Earth fault which interferes with the temperature gauge

Applies to DC11 and DSC12.

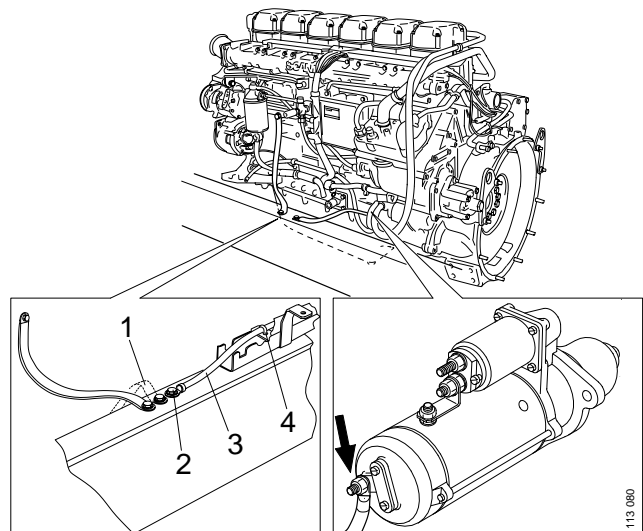
There have been incidences when the coolant temperature gauge has indicated an incorrect temperature. Inadequate earthing between the chassi and the engine is the cause. Currently earthing is achieved between two earth braids which are placed in the engine frame and side-covers.

One of the earth braids 1 378 852 is removed in production and replaced by an earth cable. One of the earth cable ends is fitted to an already existing hole in the frame and the other end is fitted to the starter motor, see illustration.

- 1 *Outgoing earth braid 1 378 852*
- 2 *Screw 813 005*
- 3 *Earth cable 1 378 324*
- 4 *Strap 815 363*

- 1 The old production solution.
2 After the service solution.

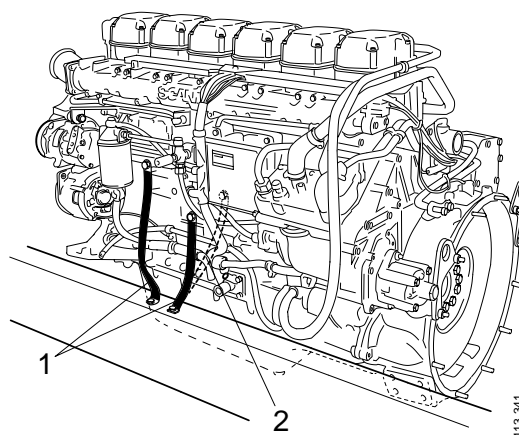
Move the rear side cover earth braid to a suitable casting protrusion on the cylinder block. Scrape off the colour on the cylinder block before fitting the earth braid to the new earth point.
